## **HAMM FAMILY DIVISION SUBDIVISION**

APPLICATION NUMBER 9 DATE July 17, 2014

# DETAIL SITE PLAN

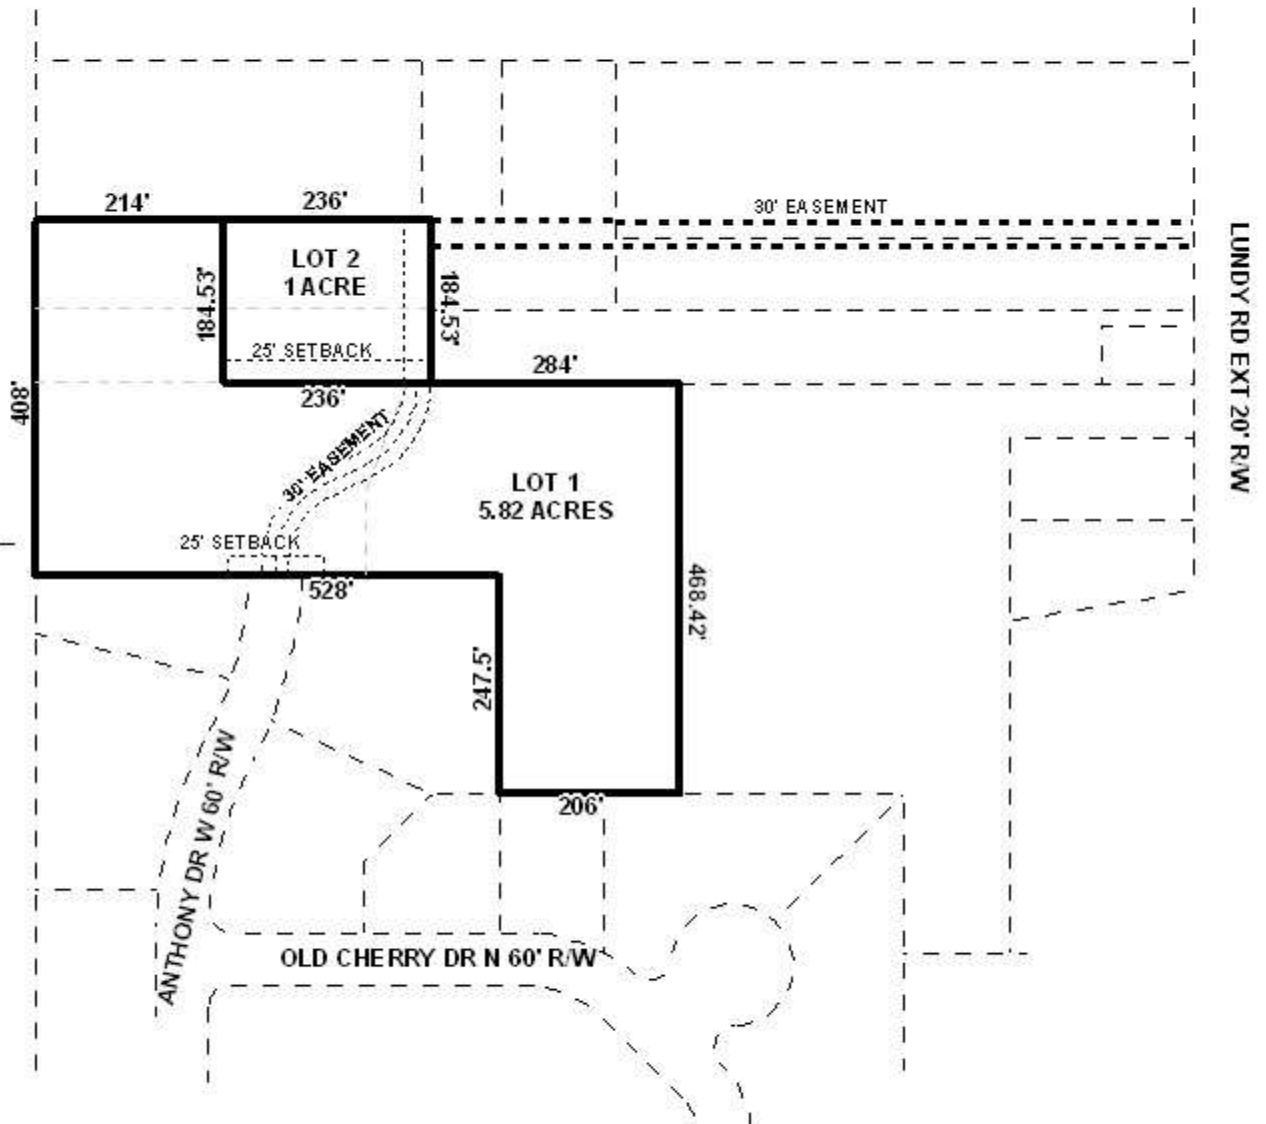
As shown on the preliminary plat, the 25' building setback line for Lot 1 should be blocked at the North terminus of Anthony Drive West. The plat should be revised to stop the 25' building setback line along the South side of Lot 2 where it would meet a 25' setback from the 30' easement for ingress and egress. The plat should also be revised to illustrate such setback line from the easement.

It should be noted that Planning GIS identified an error in the legal description along the East side of proposed Lot 2 indicating a length of 102.00' as opposed to the 184.53' as indicated graphically. This should be corrected on the Final Plat, if approved.

The proposed subdivision consists of four metes-and-bounds parcels, three of which are included in their entirety. However, the fourth parcel (R023407364000011.), which extends from the West line of the subdivision to the West side of Lundy Road Extension, is not included in its entirety. The proposed subdivision is a family division and the applicant's parents own that particular parcel but they do not wish to, nor will they, participate in the subdivision. Nonetheless, the remainder of that parcel should be included as a third lot in this subdivision. Inasmuch as all properties included are within the same family, Section 1.E. of the Subdivision Regulations provides that every plat of land that is a subdivision shall be presented for approval. Since the portion of this parcel included in the subdivision was not previously separated from the parent parcel via a deed, and the current owner will not participate in the subdivision, the exclusion of the remainder of the parcel from the application is not in compliance with the Subdivision Regulations. Therefore, this application should be recommended for denial.

The plat does not meet the minimum requirements of the Subdivision Regulations and is recommended for denial in that it is contradictory to Section 1.E. of the Subdivision Regulations for the following reasons:

- 1) only a portion of Parcel R023407364000011. is included; and
- 2) the subdivision should be a three-lot subdivision to be legal.
